Limited Visual Dam Safety Inspections

Summary ReportA-085

HC&S Reservoir 80

Dam ID:	**MA-085**
Name:	**Reservoir 80**

085 crest 2

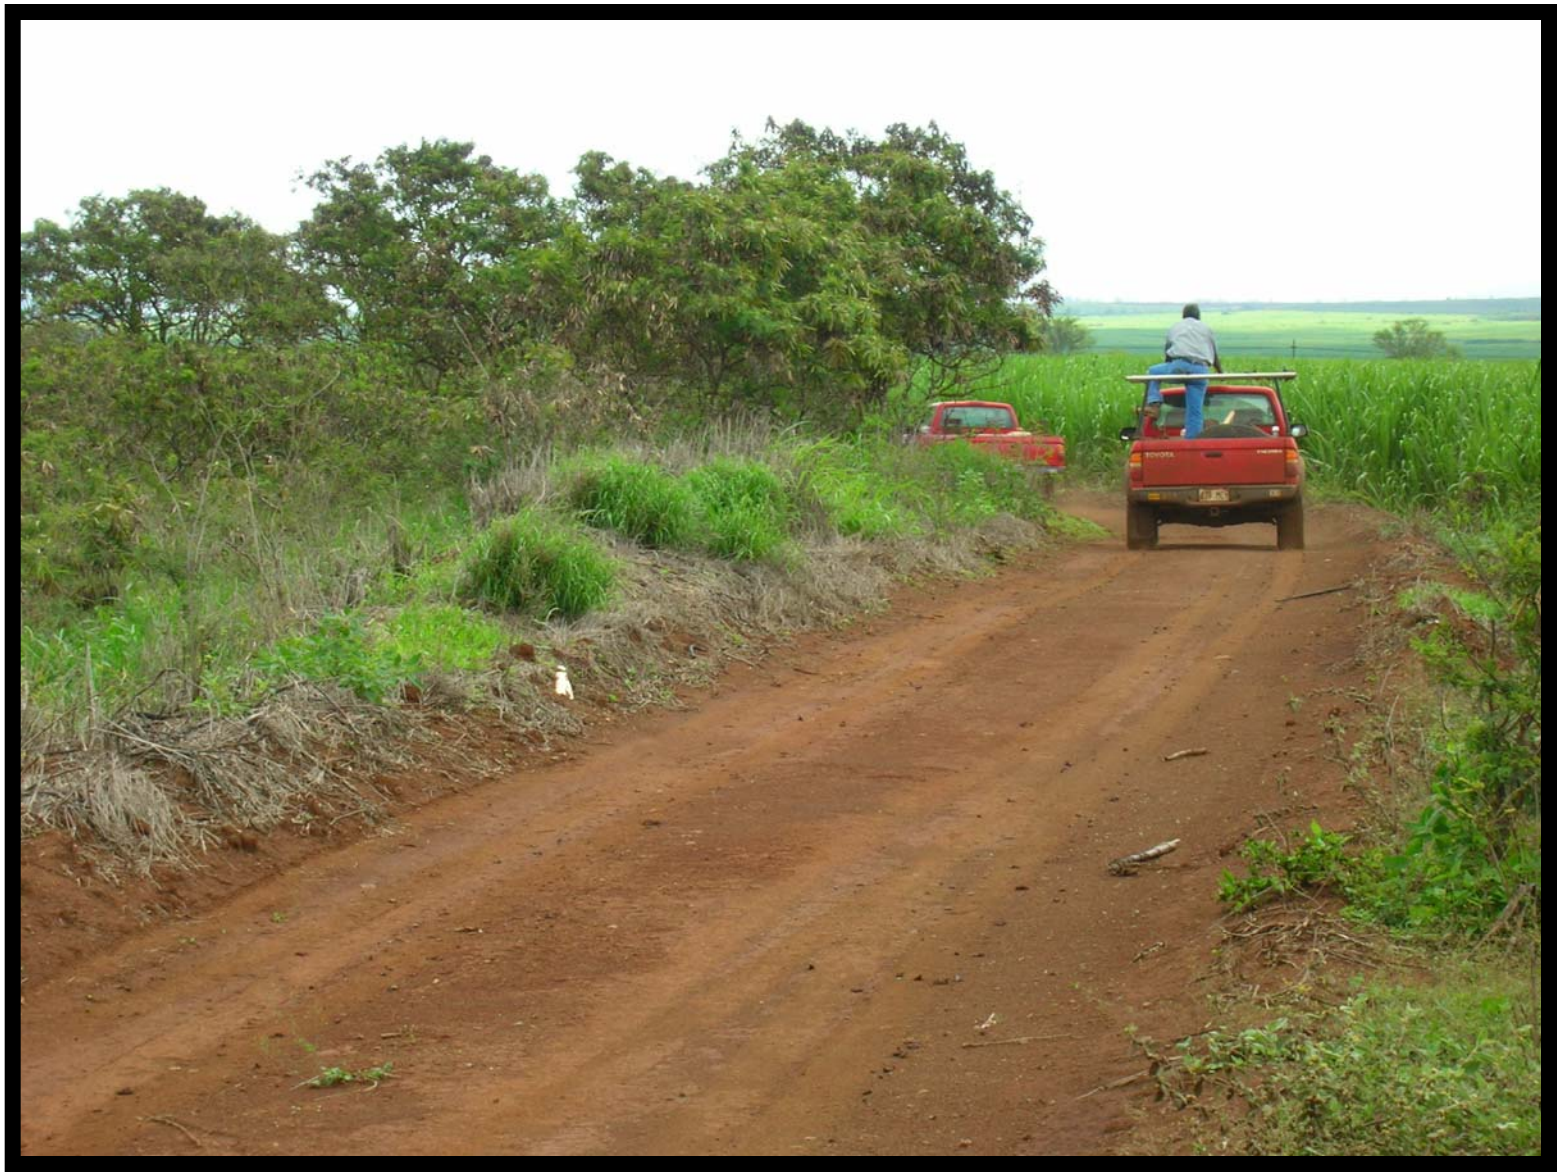
F. Crest: (Fair)
The dam crest was approximately 15 feet wide
There was a dirt access road on top of the crest, which appeared to be well utilized.
Cracks were not observed, however the crest was not entirely visible.
Sinkholes were not observed, however the crest was not entirely visible.
Heavy vegetation was observed on the crest. These were primarily small woody vegetation and high grass.

Findings and Corrective Actions:
a. The dam crest appeared to be in fair to poor condition and requires corrective action.
b. Portions of the crest were not visible due to high grass and bush vegetation. Clear high vegetation and maintain low to enable easy visual inspection.

c. Tree(s) were observed along the dam crest. Trees have been identified as the probably cause of piping failures, and can possibly cause sever damage to the embankment if they are uprooted during a high winds. Corrective action is required to remove the tree hazards from the dam. Acceptable remedies include removal of the tree and its root structure down to a 2" diameter and reconstructing the damaged embankment section. All repair work shall be accomplished as per the requirements of licensed geotechnical or structural engineer. Routinely monitor the damaged area for signs of settlement and seepage.

085 inlet3

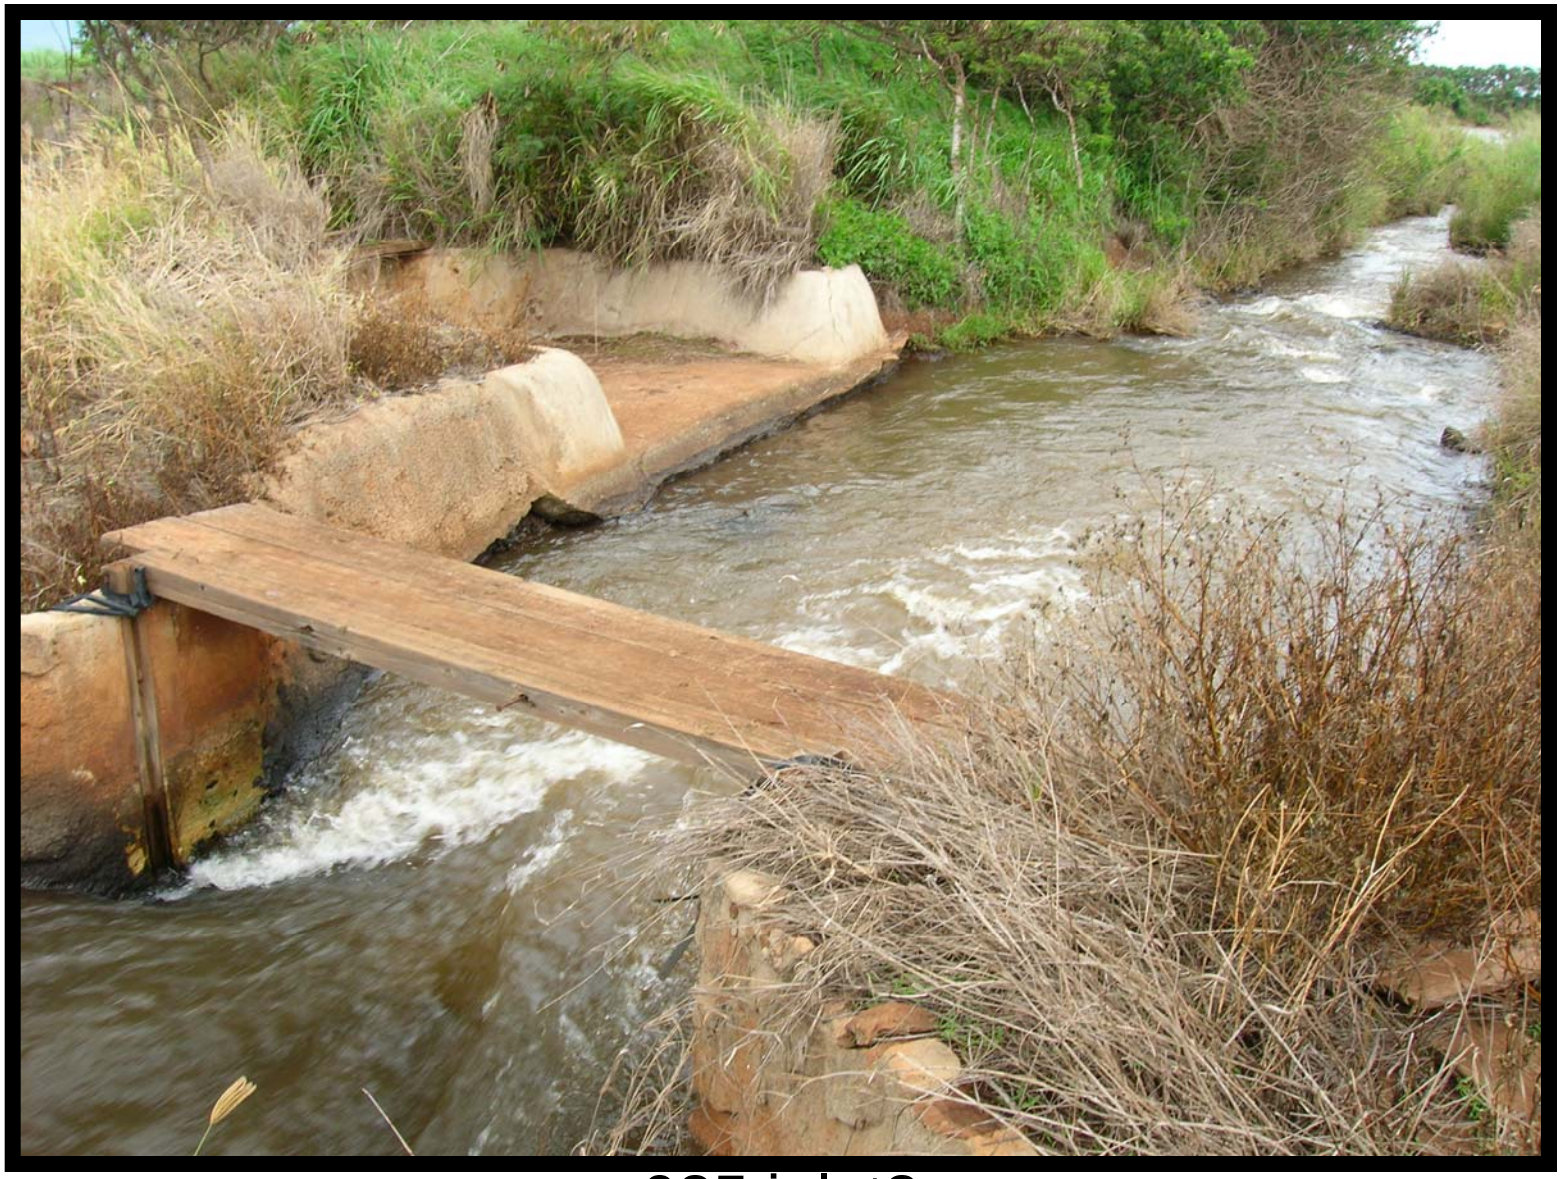
C. Intake Works: (Satisfactory)
There is 1 inlet feeding the reservoir. This inlet consists of a 10ft wide by 3 ft deep open channel concrete lined flume. The intake or inlets have the ability to be shut off or diverted away from the reservoir during periods of heavy rains. This is done manually.

Findings and Corrective Actions:
a. The intake works were not tested.
b. The intake works appeared to be in satisfactory condition, no corrective actions are required at this time.

085 outlet 2

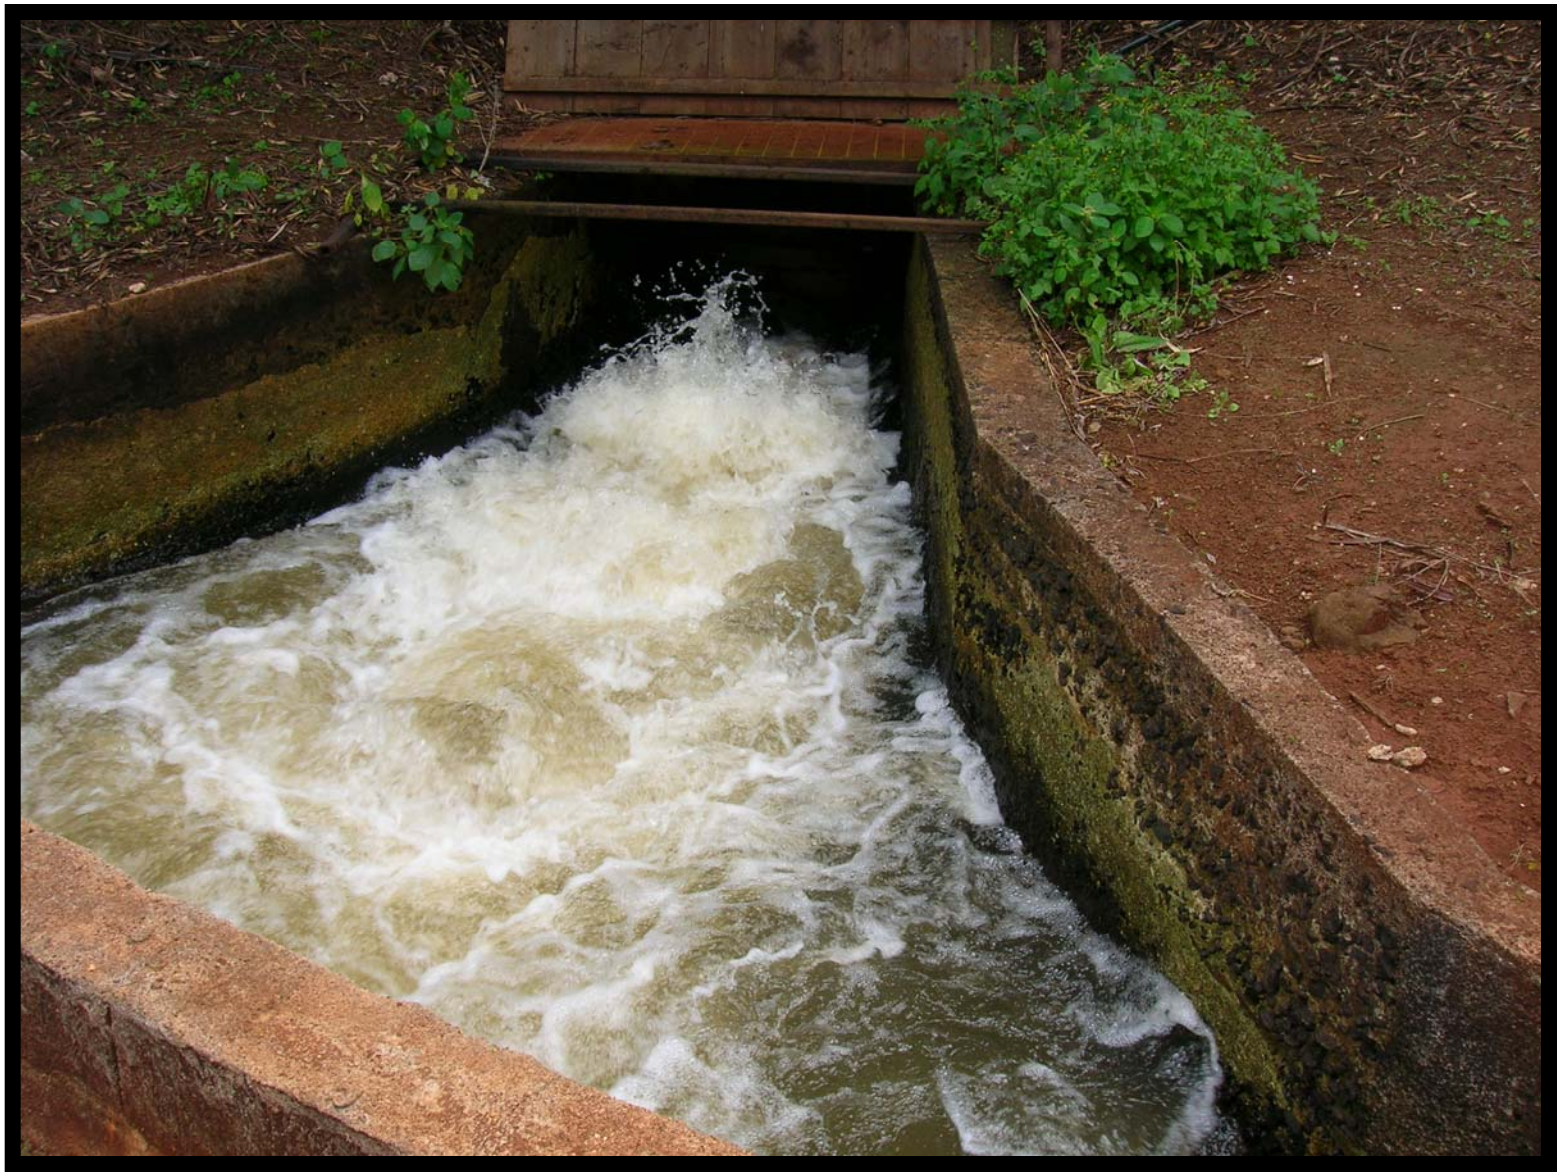
The outlet works appeared to be an 18" steel pipe.
Not inspected in detail, not tested.
The outlet works was controlled via a gate valve on the downstream side of the dam.
Seepage was not visible flowing near the exit of the outlet works from the dam.

Findings and Corrective Actions:
a. The outlet works were not tested.
b. The outlet works appeared to be in satisfactory condition, no corrective actions are required at this time.

085 reservoir 2

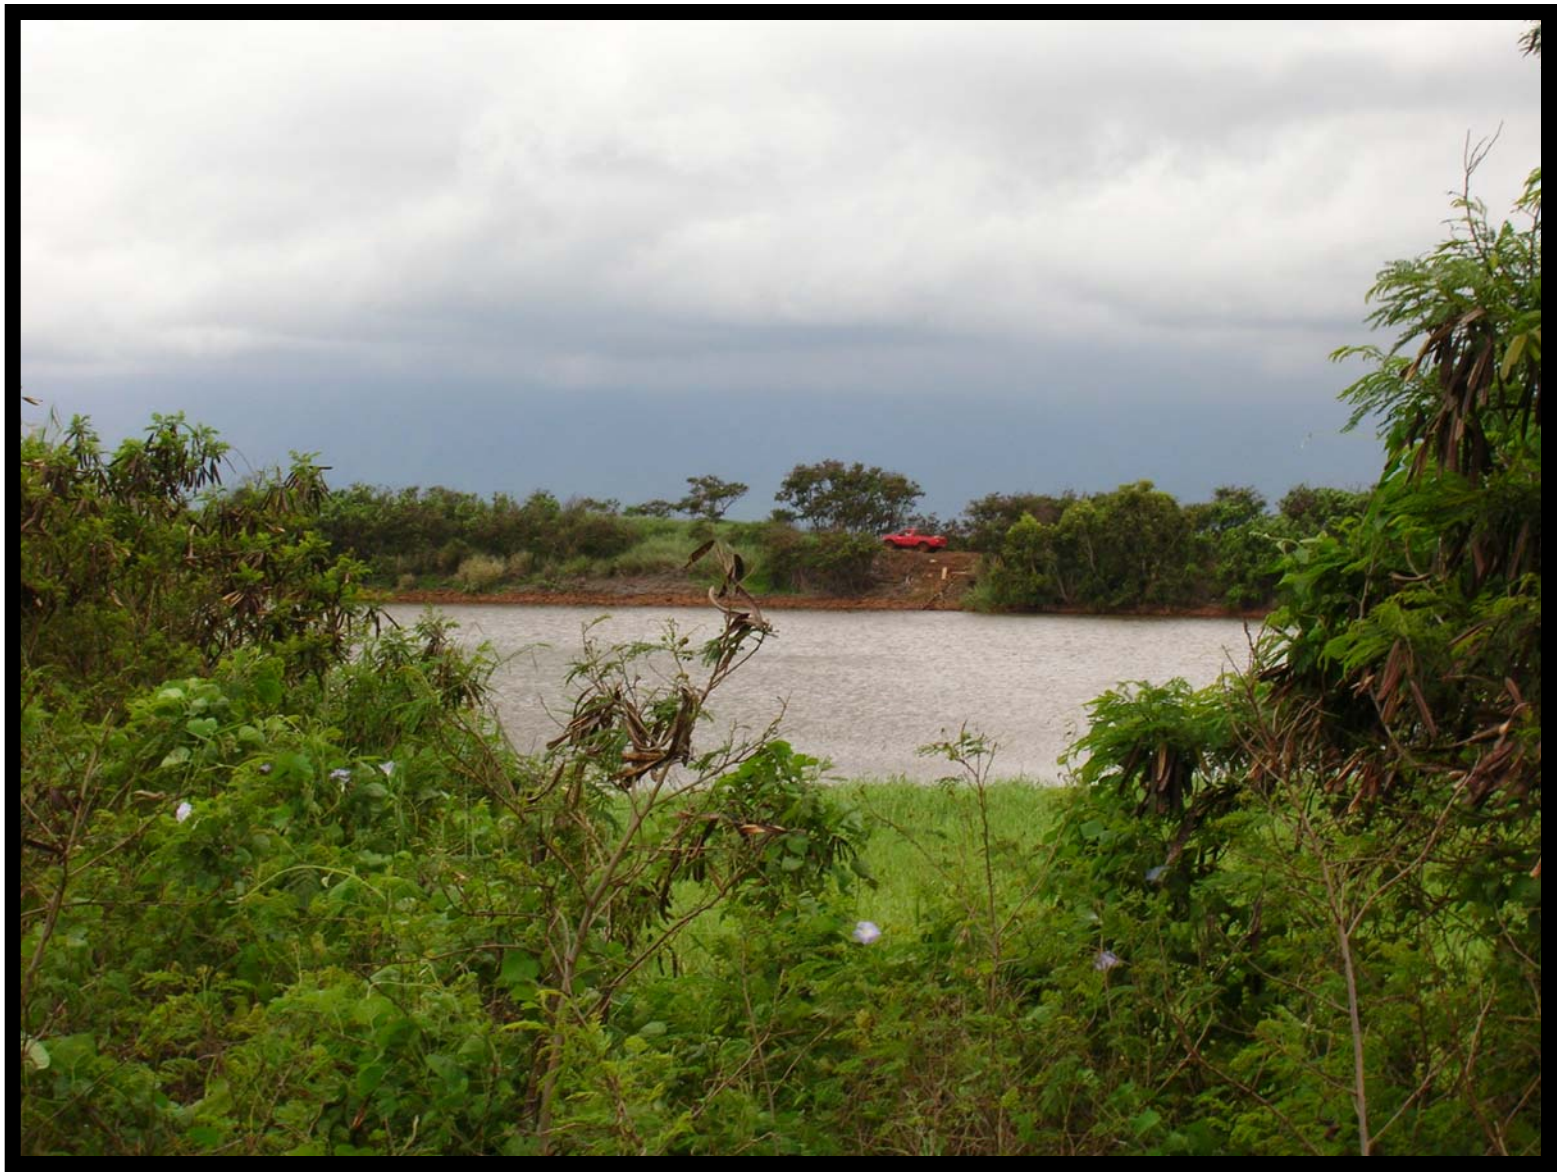
D. Reservoir: (Satisfactory)
The reservoir level during the inspection was 14 feet.
According to staff personnel, the reservoir is normally operated between the ranges of 8' to 17'.

Findings and Corrective Actions:
a. The reservoir appeared to be in satisfactory condition, no corrective actions are required at this time.

085 spillway

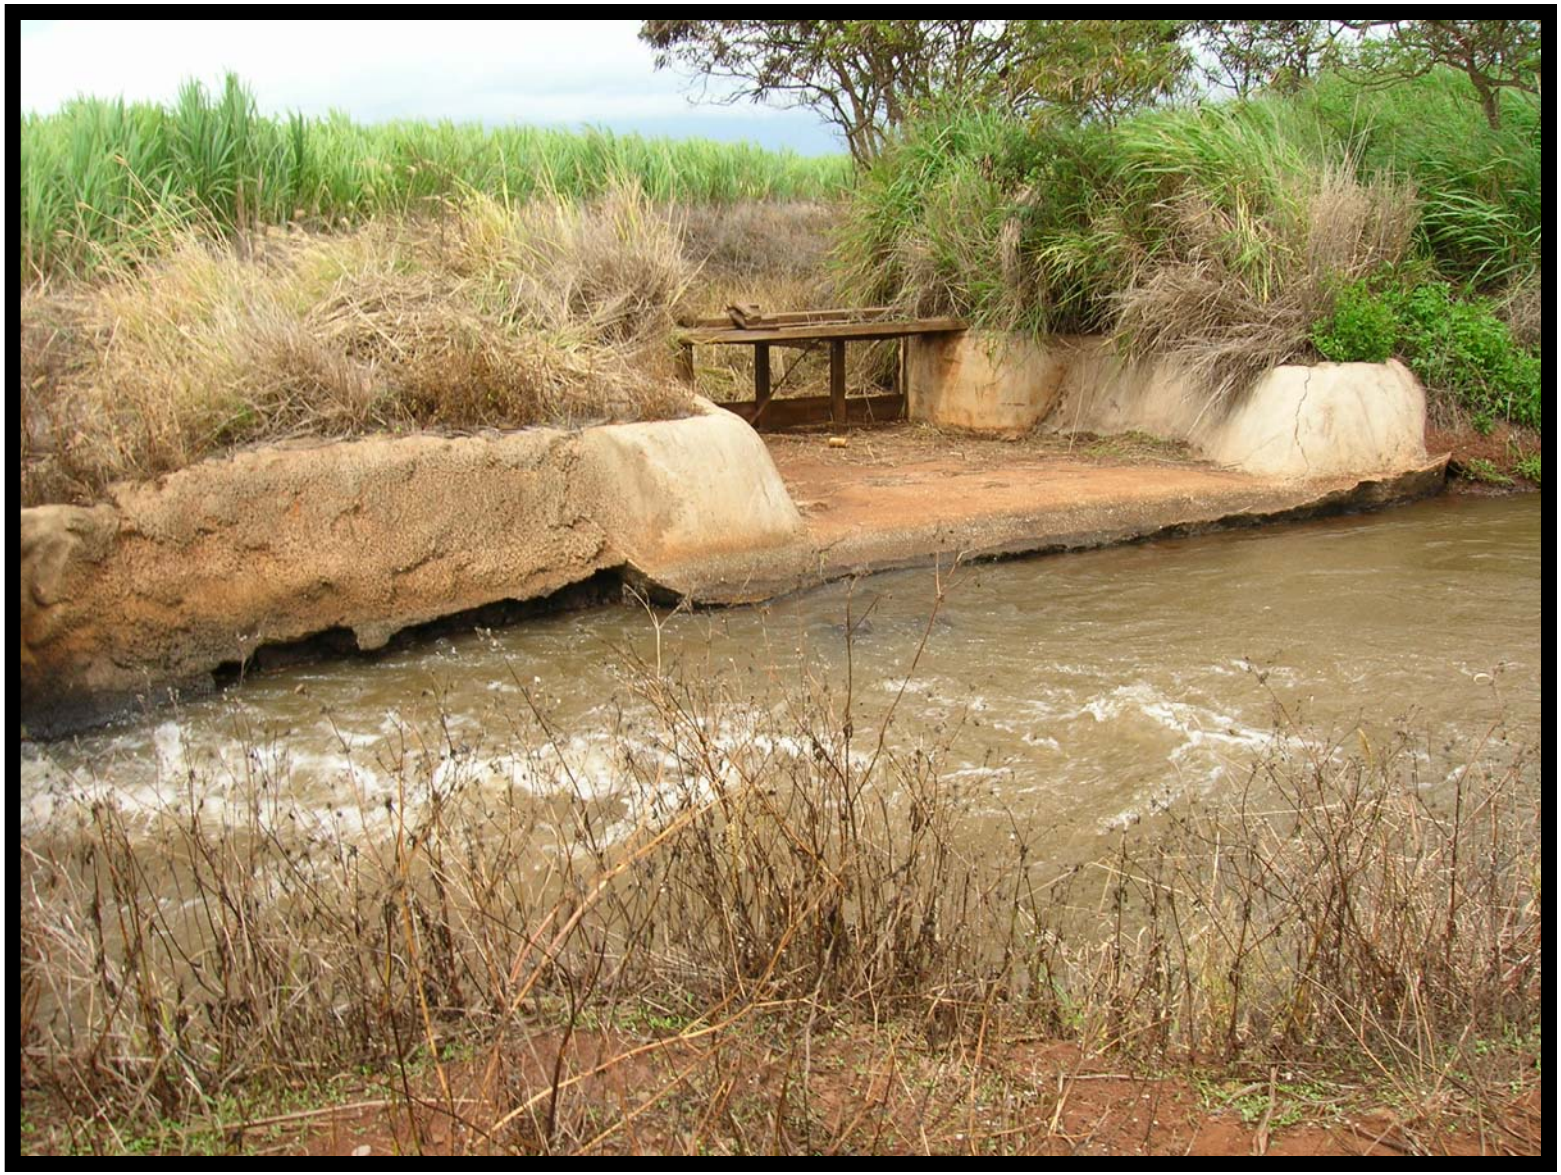
This spillway consisted of a 10ft wide by 2ft deep channel that is concrete lined near the reservoir.
The spillway approach was clear.
There was no erosion observed near the spillway.
Further investigations should be conducted to conclude the capacity of the spillway.

Findings and Corrective Actions:
a. The Spillway appeared to be in fair to poor condition and requires corrective action.
b. Unclear if spillway is adequately sized. Spillway should pass the probable maximum flood. Verify spillway capacity and take corrective action as required.
